Access Compliance Report

Public Rights-of-Way

| Intersection ID: N/A | Main Street: E_WOODLAWN_RD | Cross Street: N/A | Location: NW |
| ADA ID: 775E473B0687 | Ramp Type: Directional1 | Initial Pass/Fail: Fail | Overall Compliance: No |

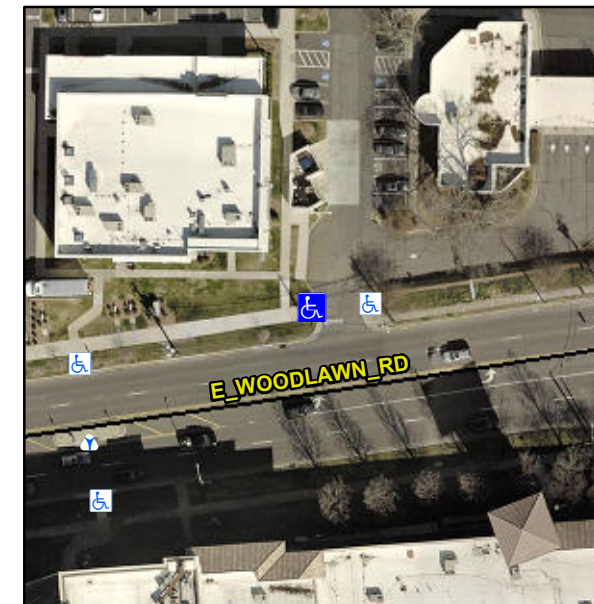
R304.5.3

| Compliance | Description | Data | Compliance | Description | Data |
|------------|-----------------------|------|------------|-----------------------------|------|
| No | Ramp XSlope (%) | 2.2 | | | |

Remove & Replace Entire Ramp.
